Model: Aprilia RS - Tuono 660

Subject: Availability of engine ECU calibration update

Figure 1

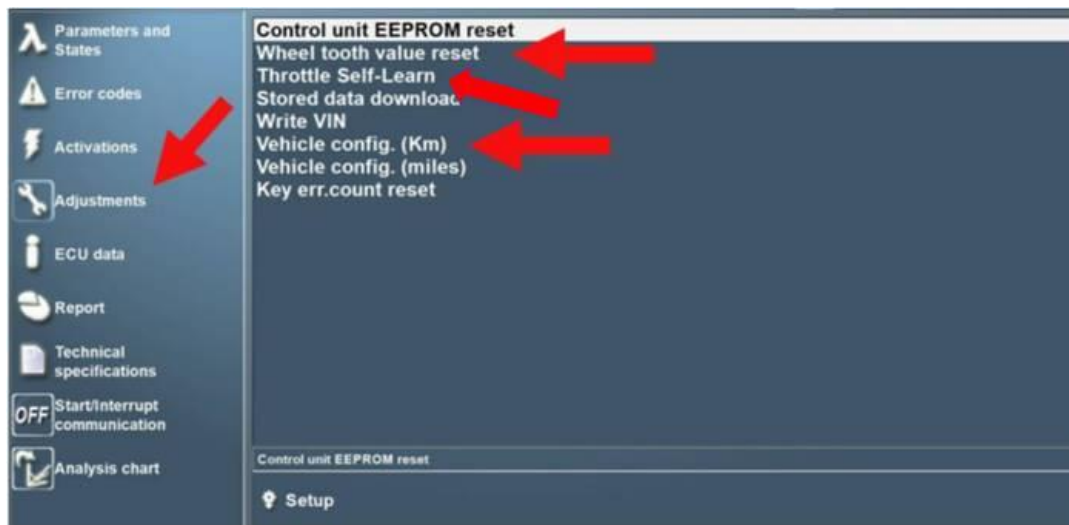
- Perform a key off / key on
- Perform the **crankshaft tone wheel acquisition procedure** (ONLY EMEA VERSIONS - see procedure on page 2)
- Perform the **Vehicle configuration in Miles or Km** (based on unit of measurement used for respective country) (see figure 1)
- Carry out throttle valve self-learning (see figure 1)
- Access the vehicle ECU menu and cancel any errors.

- Perform “Reset wheel tooth value ” with the PADS tool (see figure 1)
- Warm the engine to 80°C
- With the gearbox in neutral, the side stand extended and the vehicle completely stationary, **throttle up to over 8000 rpm at least three times**
- **Switch the ignition off and wait at least one minute** (Power Latch)
- The status “**Flywheel Self Learning**” under parameter and status selection should say “**Done**” if the RPM rev procedure was performed correctly.
